CITY OF NEWTON, MASSACHUSETTS

SUBJECT: **#391-07 JOHN NIGRO/PACKARD COVE ASSOCIATES** petition for a SPECIAL PERMIT/SITE PLAN APPROVAL to locate a for-profit dance studio in an existing building and to waive dimensional and setback requirements for parking, light poles, lighting, interior landscaping and to allow parking in an existing off-site facility, at 105 RUMFORD AVENUE, Ward 4, on land known as Sec 41, Blk 35, Lots 1A, 14 and a portion of lot 5 in a district zoned MANUFACTURING. Ref: Sec Special Permit #19-06 and 30-24, 30-23, 30-5(b)(2),

Zoning Review Memorandum

Re: For profit dance school.

PLAN OF LAND
NEWTON, MA
105 RUMFORD AVENUE
PROPOSED CONDITIONS

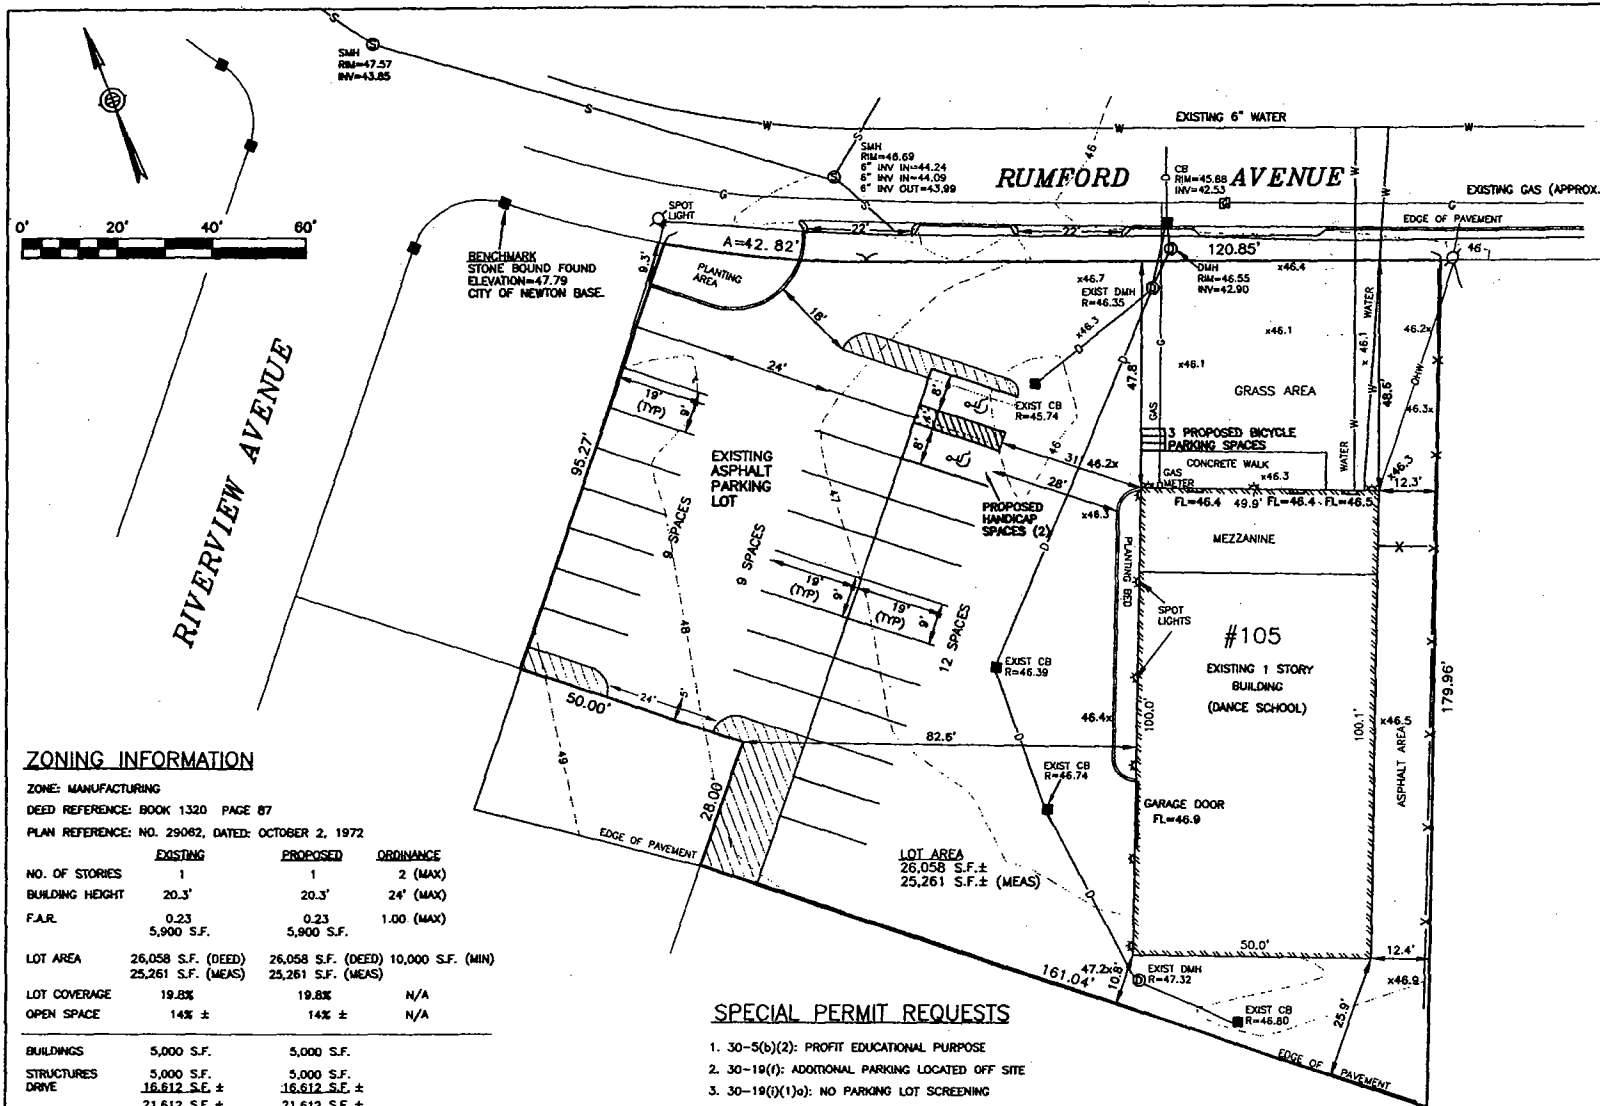
3. Section 30-19(d)(10), (11) and (13) set out the applicable parking requirements for the required number of stalls. The applicant has provided some parking assumptions and calculations on the "Proposed Conditions" plan. Although the City requested on November 1, 2007, that the applicant provide a floor plan showing proposed use of the building including audience events, in particular indicating seating and/or

4. The following required parking is estimated based on extrapolation of incomplete information and is not conclusive. Floor plans showing actual proposed use of all areas of the building are still needed. The property owner indicates that the building was previously occupied by a medical supply company for office, shipping, receiving, and warehousing. The applicant's attorney explains that the owner estimates the prior maximum employee number to be 20-30, based on observed near capacity use of the existing 30-space parking lot. The following is a preliminary estimate of required parking based on Section 30-19(d)(10), (11) and (13) and may change subject to receipt of noted information.

As 30 stalls are indicated on plan, there would be shortfall of 16 spaces. The applicant may seek a waiver per Section 30-19(m) subject to approval of the Board of Aldermen. Alternatively, The applicant may seek approval of off-site spaces pursuant to Section 30-19(f)(2), as discussed in Section 5, below.

7. *Section 30-19(h)(2)c Design of Parking Facilities -- for the physically handicapped*, requires 2 handicapped (HP) stalls in relation to the number of parking spaces on site. While 2 HP spaces are provided, it is noted that one of the two HP stalls does not meet the minimum 12 ft. width applicable to HP stalls. The applicant should provide HP stalls meeting minimum requirements, or may seek a waiver pursuant to *Section 30-19(m)*.

minimum of 10 ft. is required). The applicant's site is abutted on the west and south sides by Manufacturing zoned properties, and on the east by City property zoned Public Use. However, the parking stalls along the west side are located immediately at the west lot line, encroaching on the 5 ft. setback. In addition, it is noted that two new 20 ft. tall light poles are proposed at the west lot line. These are deemed structures subject to the parking setback, but are located approximately 0 ft. from the west lot line. The above necessitate waivers of the parking lot setback from the Board of Aldermen per Section 30-19(m).

11. *Section 30-19(j)(1), Lighting*, establishes the illumination requirements applicable to parking facilities of this size. While a hand-marked "Exterior Lighting Plan" has been submitted, it is not entirely legible. In addition, it appears that portions of the parking area would not meet the 1 foot-candle illumination level. The applicant may wish to consider adjusting the illumination level to meet applicable standards, or may alternatively request a waiver to reduce illumination, per Section 30-19(m), subject to approval of the Board of Aldermen. In addition, the petitioner is responsible for complying with *Ordinance X-142, Light Ordinance*, as set out in *Sections 20-23 through 20-28* with respect to *Light Pollution* and *Light Trespass*, respectively.

1. an off-site parking agreement between the owners of the dance studio and the owners of 130 Rumford Avenue, as required under Section 30-19(f)(2).
2. updated site plans for 130 Rumford Avenue to clearly indicate the location of 16 parking spaces that will be available for the use by the Balera Ballroom School of Dance between the hours of 6:30 p.m. to 11:30 p.m. on Saturday evenings.
3. temporary signage plan to inform patrons of showcase performances that parking is available for their use at 130 Rumford Avenue and to direct them safely across Rumford Avenue.
4. information about how the poles will be installed so that they are not damaged by vehicles parking or removing snow.
5. an agreement that any future children's classes or camp should be subject to the review and approval of a parking and drop-off plan by the Director of Planning and Development and City Traffic Engineer.
